## **Reply to Anonymous Referee #2 – RC1**

We thank the reviewer for their constructive review of the manuscript. We have made all of the specific recommended changes. Please see below for our response to each of the comments.

“Figure 2: Example of a regression plot that demonstrates the optimization process we used to calculate an RMRI for each survey. The RMRI for each survey was chosen where the two linear regression lines intersect.”

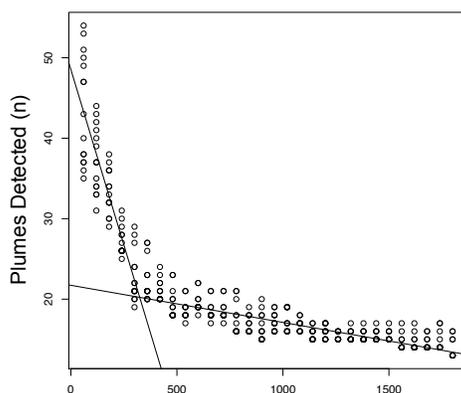
- P5 L10-12: *"Our optimal RMRI was taken to be the point at which anomalies were maximized, but also where we avoided the rapid noise-associated increase associated with extremely short RMRI's": in practice, how was this optimization performed? It appears to be a subjective choice. Is this true? It would be preferable if the choice was made objectively using quantitative criteria; it would also be preferable to have the same algorithm be used for all surveys.*

We did not choose the RMRI value for each survey subjectively. The optimization was performed with an algorithm that was applied to all surveys individually. We have added the following figure and associated text to the paper to clarify the quantitative process we used to determine the RMRI for each survey. Please see

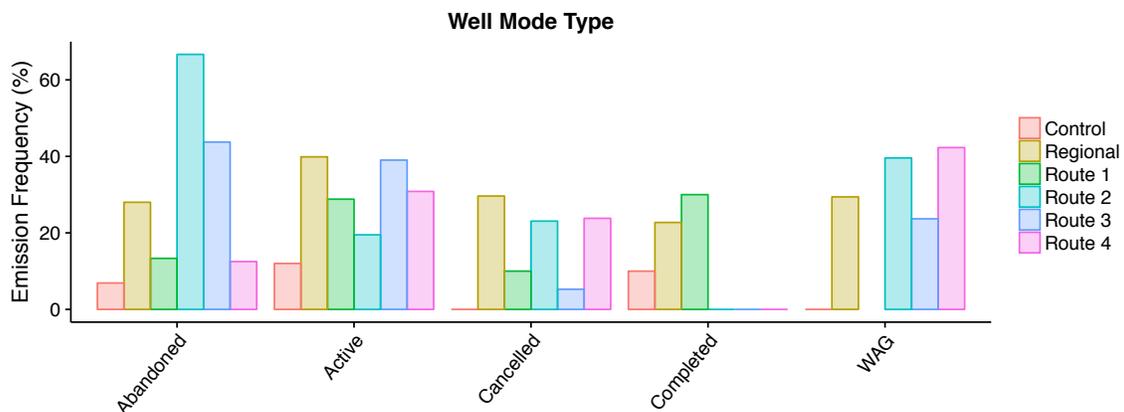
*Fig 5: In some panels (e.g., the top panels), the regression lines do not pass through zero. This doesn't make any physical sense. Why should there be a threshold for number of wells surveyed below which no emissions should occur? Why would there be no emissions for surveys with fewer than 60 wells surveyed? I don't understand the rationale for a linear regression. Why not simply ratio the total number of sites with emissions / total number of sites surveyed across all surveys for each category? This would make more intuitive sense. Alternatively, the linear regressions could be forced through zero, which would be similar.*

*Fig 6 and 7: similar comments to above for Fig. 5.*

We agree and have changed the linear regression plots to bar graphs which show the percentage of infrastructure emitting for each source-type. Please see the graphs and captions below. We have also made minor changes to the manuscript text accordingly.
